NP-11-0028  
June 30, 2011

Subject: Exelon Nuclear Texas Holdings, LLC  
Victoria County Station Early Site Permit Application  
Response to Request for Additional Information Letter No. 07  
NRC Docket No. 52-042

Attached are responses to NRC staff questions included in Request for Additional Information (RAI) Letter No. 07, dated April 8, 2011, related to Early Site Permit Application (ESPA), Part 2, Sections 02.04.06, 02.05.02, and 11.02. NRC RAI Letter No. 07 contained twenty Questions. This submittal comprises a partial response to RAI Letter No. 07, and includes responses to the following two (2) Questions:

**Figure 2.4.6-10 Maximum water surface elevations (MSL) for simulation case PV. Maximum tsunami runup elevation: 1 m (MSL), with negligible inundation past the barrier islands. Bathymetry elevations are relative to MSL.**

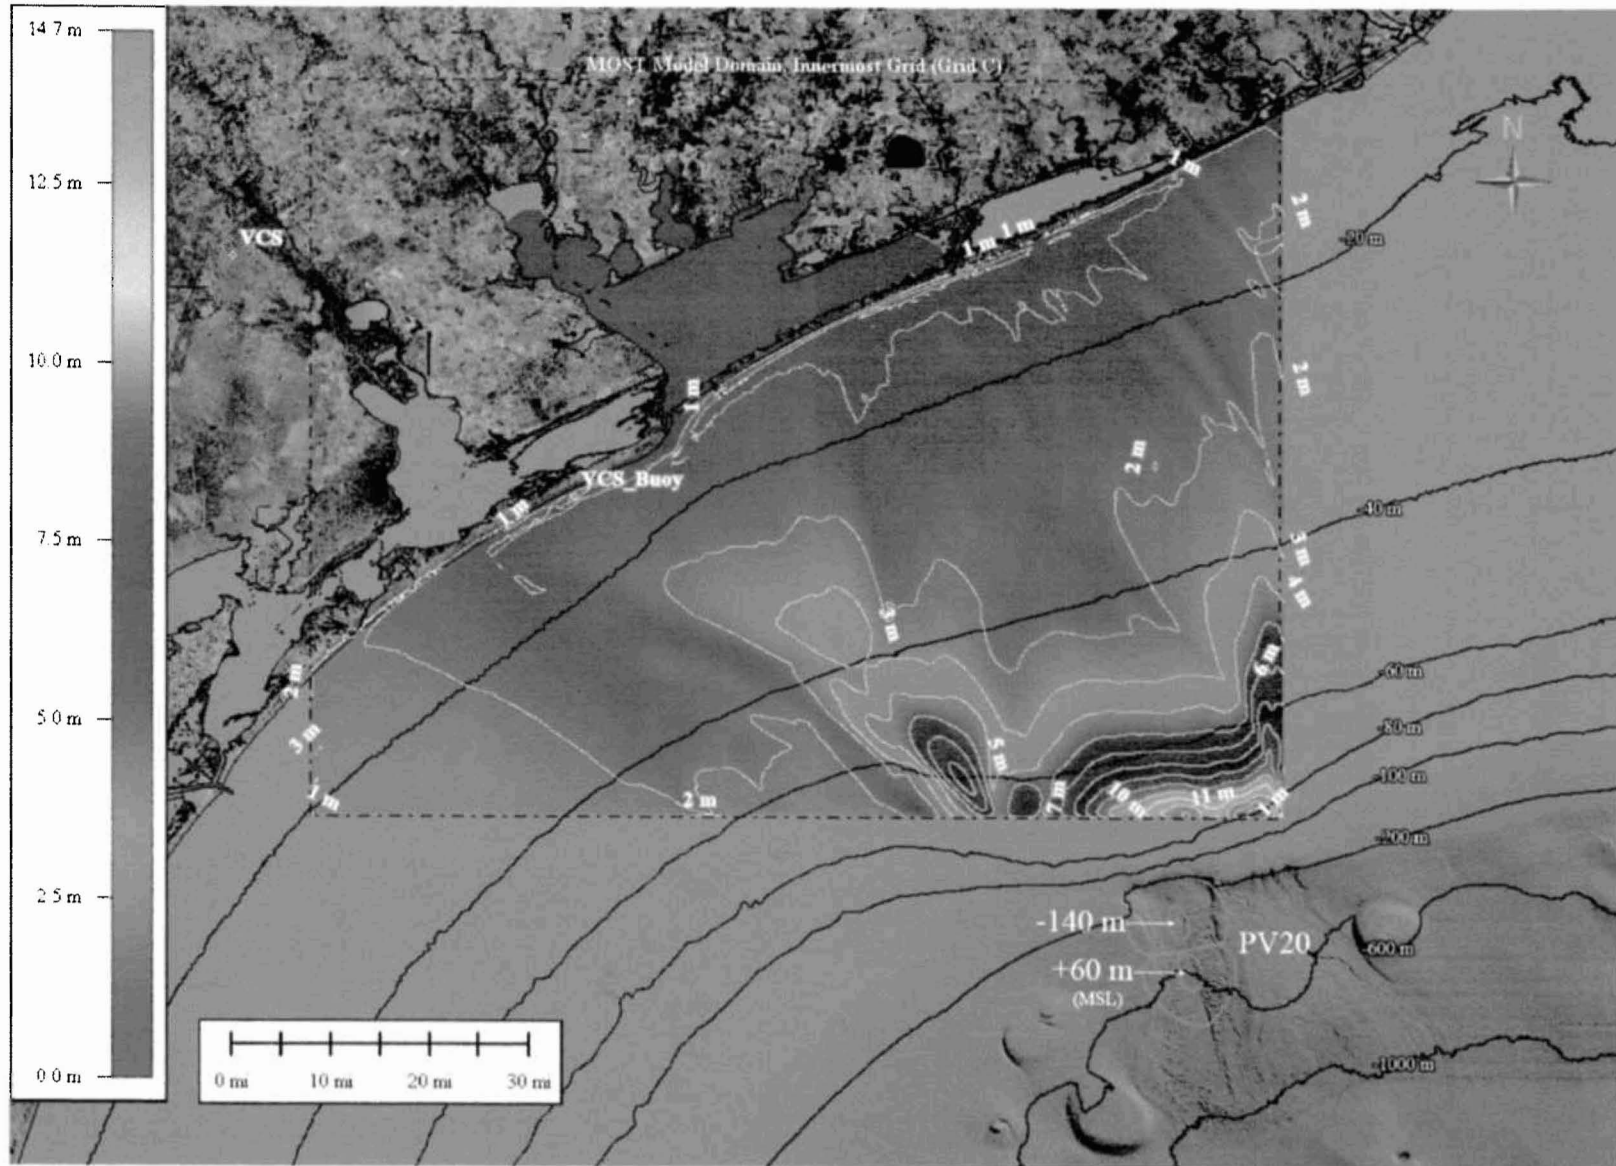
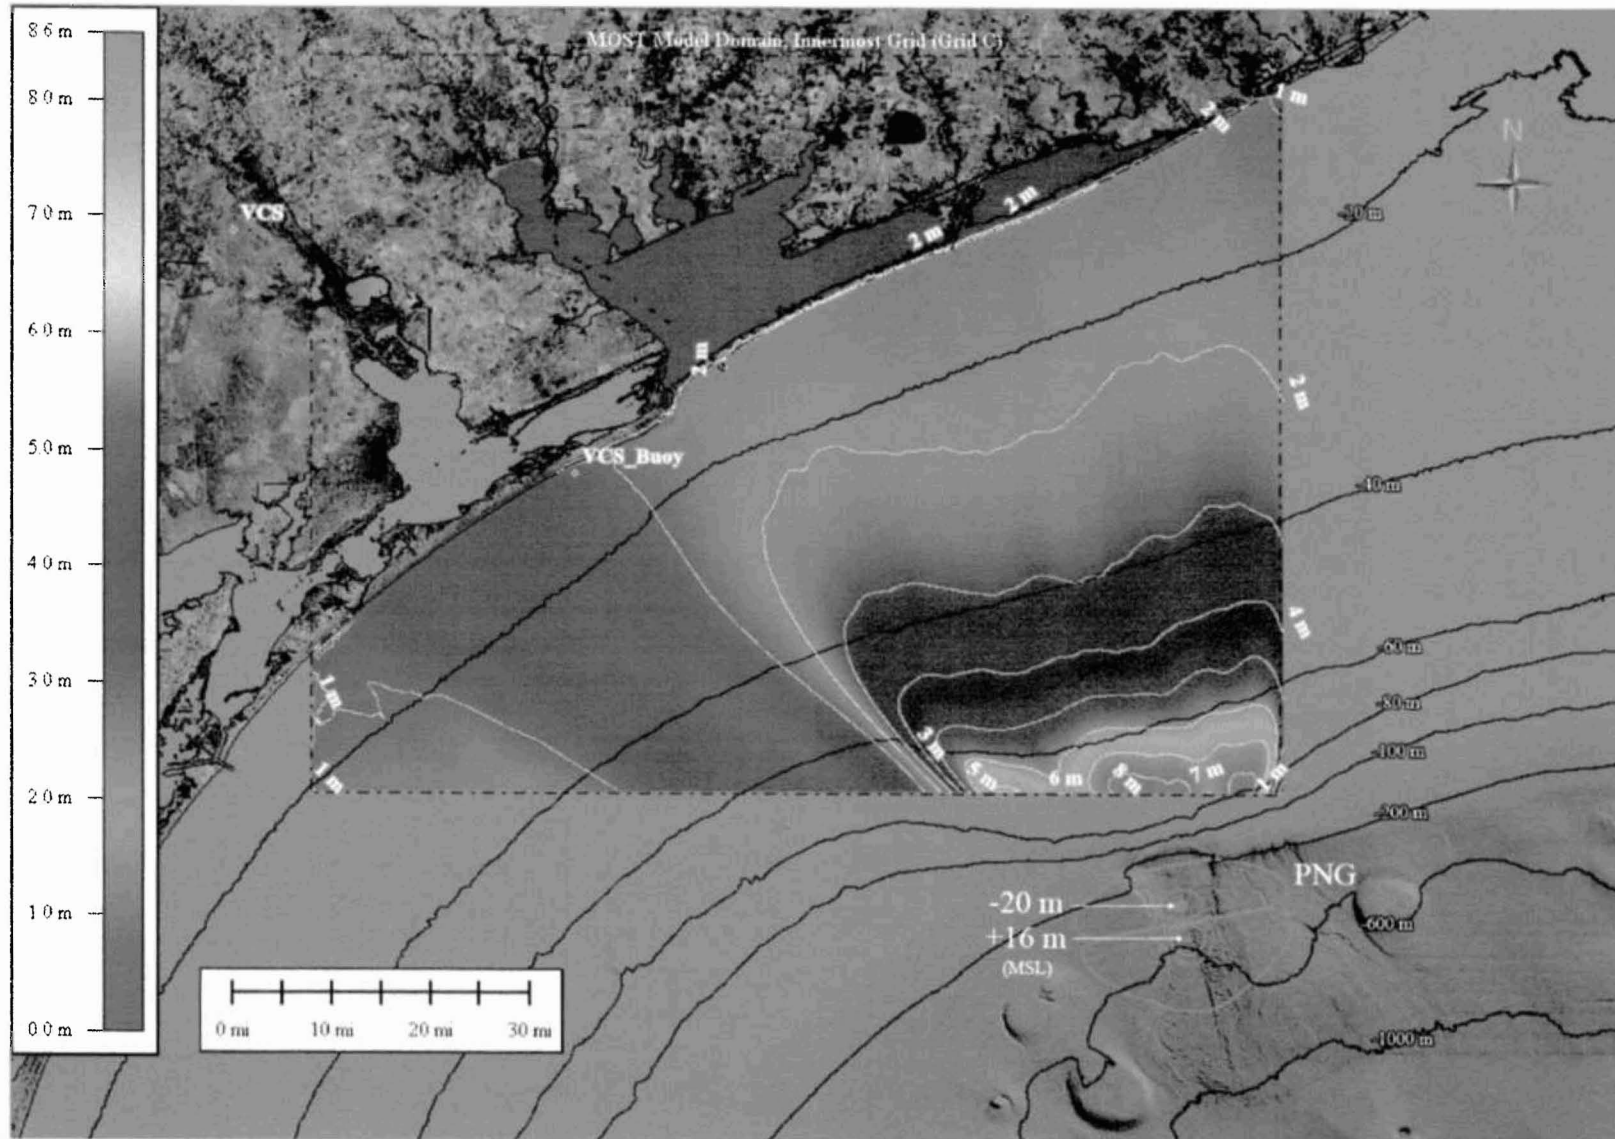
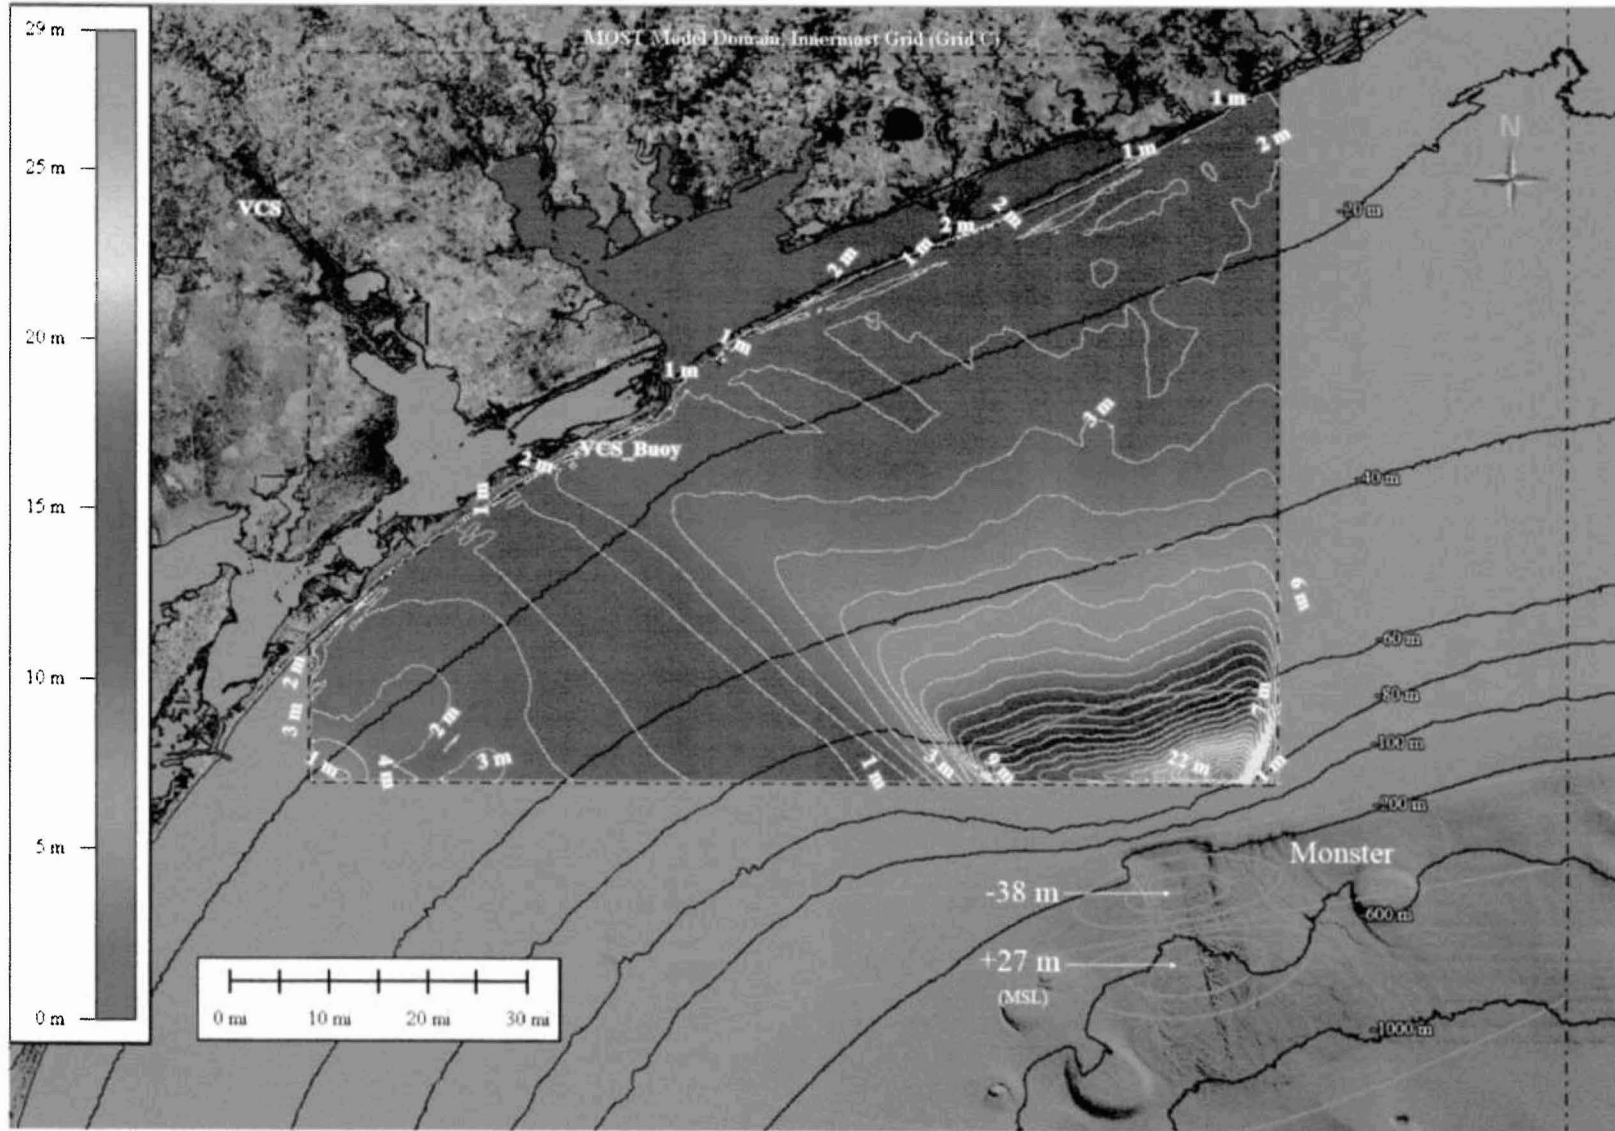
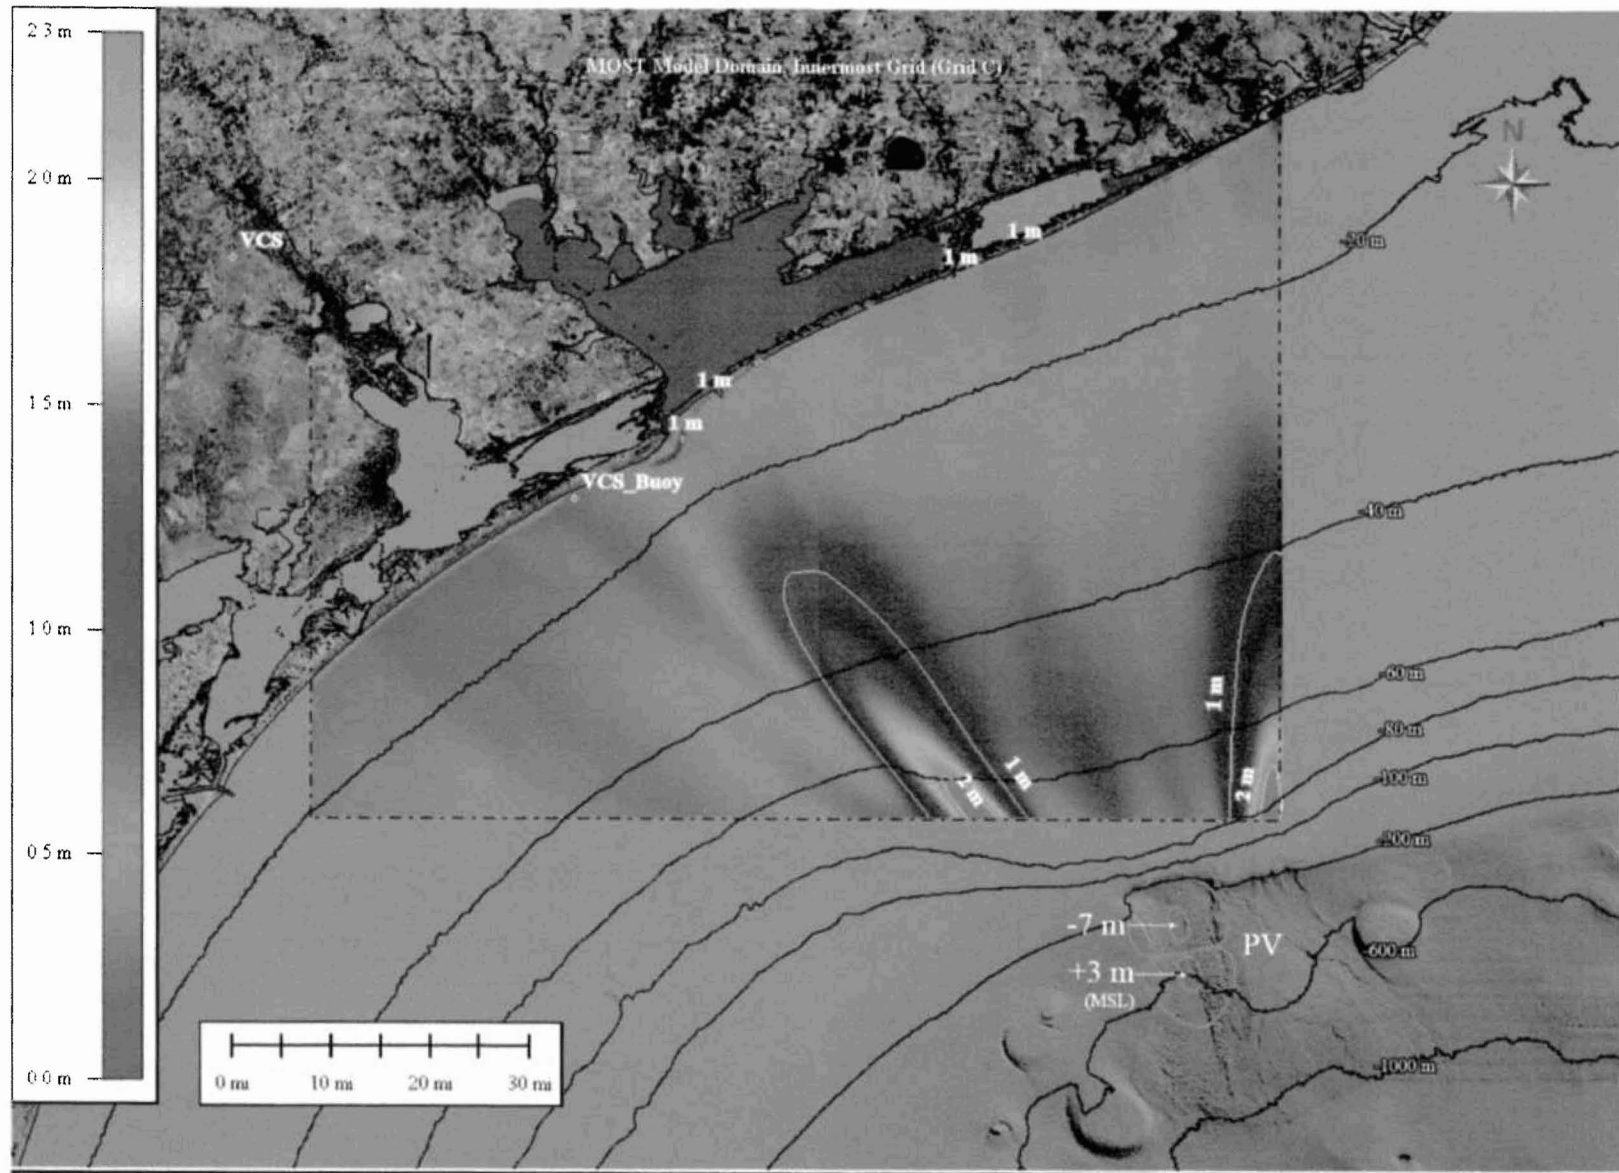
- (2) Propagation of the PMT from the source to the site, using bathymetric, coastline, and topographic information specific to the site.

Initial wave dimensions for the PV, PV20, PNG, and “Monster” simulation cases are shown in the attached proposed SSAR Figures 2.4.6-10, 2.4.6-11, 2.4.6-12, and 2.4.6-13, respectively. Initial wave elevations are relative to 0 m (0 ft) MSL. Initial wave trough elevations varied from -7 m to -140 m (-23 ft to -459 ft, respectively) (MSL) and initial wave crest elevations varied from 3 m to 60 m (9.8 ft to 197 ft, respectively) (MSL) (Table 1). Initial wave widths varied from 14 km (8.7 mi) to 136 km (85 mi). The range of initial wave heights and initial wave widths were intended to simulate reasonably probable bounding cases for SMFs that may occur offshore of the South Texas coast.

For all MOST simulations, maximum estimated tsunami runup was 2 m (6.6 ft) (MSL) (Table 1). Plots of maximum wave amplitude for each simulation case (PV, PV20, PNG, and “Monster”) are shown in the attached proposed SSAR Figures 2.4.6-10, 2.4.6-11, 2.4.6-12, and 2.4.6-13, respectively. All simulation cases showed significant diffusion of the initial tsunami wave during propagation on the continental shelf (Reference 8). Time series of water surface elevations for a hypothetical buoy location near the coastline of VCS for the PV, PV20, PNG, and “Monster” simulation cases are shown in the attached proposed SSAR Figures 2.4.6-14, 2.4.6-15, 2.4.6-16, and 2.4.6-17, respectively. For wave energy that did reach the South Texas coast, relatively little inundation occurred, with most of the wave energy being reflected by the barrier islands back into the Gulf of Mexico.

MOST output includes maximum runup estimates (maximum inland elevation inundated by the tsunami above 0 ft MSL). Maximum runup ranges from 1 to 2 m (3.3 to 6.6 ft, respectively) MSL along the South Texas coast (Table 2.4.6-4). The simulations indicate that a landslide tsunami originating from the East Breaks slump location would be unlikely to cross the barrier islands at the coastline near VCS and produce a runup in excess of 2 m (6.6 ft) (MSL) (Figure 2.4.6-10, Figure 2.4.6-11, Figure 2.4.6-12, and Figure 2.4.6-13).

Plan view plots of maximum wave amplitude relative to the East Breaks slump and the South Texas coast for PV, PV20, PNG, and the “Monster” simulation cases are shown in

Figure 2.4.6-10, Figure 2.4.6-11, Figure 2.4.6-12, and Figure 2.4.6-13, respectively. Time series of water surface elevation above MSL for a buoy location at the coastline near VCS for the PV, PV20, PNG, and “Monster” simulation cases are shown in Figure 2.4.6-14, Figure 2.4.6-15, Figure 2.4.6-16, and Figure 2.4.6-17, respectively.

**Figure 2.4.6-18 Synthetic tsunami time series (marigrams) for the Campeche hypothetical landslide scenario and East Breaks landslide scenario. Water surface elevations relative to MSL. Ocean water depth assumed to be 50 m (Source: Reference 2.4.6-18).**

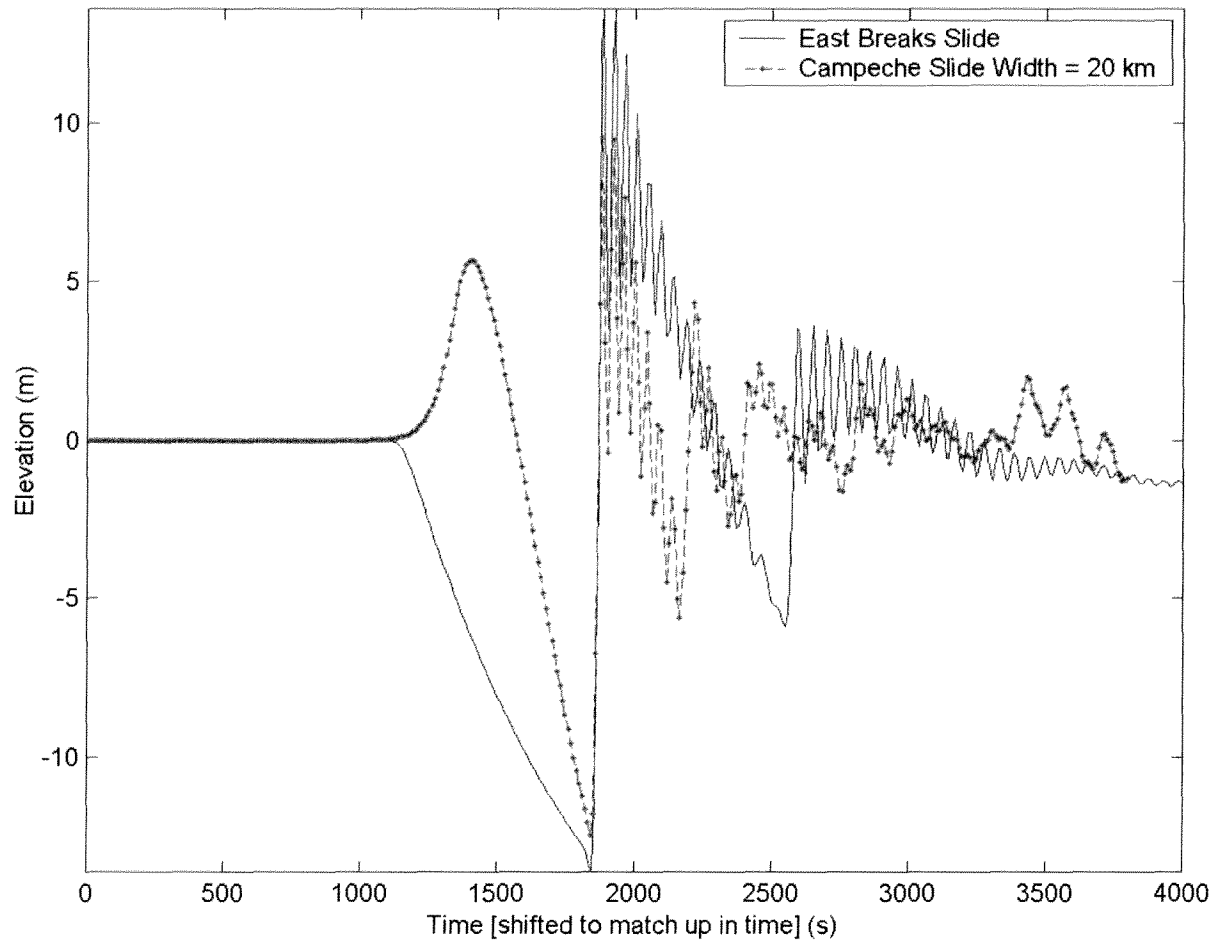
***In addition, provide a rationale for choosing the East Breaks slide as the PMT source among other potential sources based on analysis of estimated tsunami water levels at the VCS site for each source.***

Based on the results of synthetic tsunami time series (marigrams) for sources at the East Breaks slump and Campeche Escarpments at an ocean water depth of 50 m (MSL) near Matagorda Bay, Texas (see attached proposed SSAR Figure 2.4.6-18), Reference 2.4.6-18 identifies equal tsunami runup potential from the East Breaks slump and the Campeche Escarpment, stating the following:

“It was expected that because the propagation distance for Campeche is so much larger than East Breaks (about 700 km longer), the 2D spreading effect is significant, and results in greater attenuation than for the East Breaks scenario. Figure 4-11 [which is reproduced as the attached proposed SSAR Figure 2.4.6-18] compares the ocean surface elevation time series for the offshore Campeche 20-m wide slide and the East Breaks (2HD simulations) at the same 50-m depth offshore location. The general conclusion made from this comparison is that the approaching wave heights for the hypothetical Campeche scenario are comparable to that of the East Breaks scenario, unless it is found that the maximum slide width in the Campeche province is much less than 20 km. Because the properties of the incoming waves are different (leading elevation vs. leading depression), and the uncertainty in the slide parameters, this analysis indicates that East Breaks and Campeche (20 km width) should have equal tsunami potential on the Texas coast.”

Based on the results of synthetic tsunami time series (marigrams) for sources at the East Breaks slump and Campeche Escarpments at an ocean water depth of 50 m (MSL) near Matagorda Bay, Texas (SSAR Figure 2.4.6-18), Reference 2.4.6-18 identifies equal tsunami runup potential from the East Breaks slump and the Campeche Escarpment, stating the following:

Figure 4-11 [which is reproduced as SSAR Figure 2.4.6-18] compares the ocean surface elevation time series for the offshore Campeche 20-m wide slide and the East Breaks (2HD simulations) at the same 50-m depth offshore location. The general conclusion made from this comparison is that the approaching wave heights for the hypothetical Campeche scenario are comparable to that of the East Breaks scenario, unless it is found that the maximum slide width in the Campeche province is much less than 20 km. Because the properties of the incoming waves are different (leading elevation vs. leading depression), and the uncertainty in the slide parameters, this analysis indicates that East Breaks and Campeche (20 km width) should have equal tsunami potential on the Texas coast.”
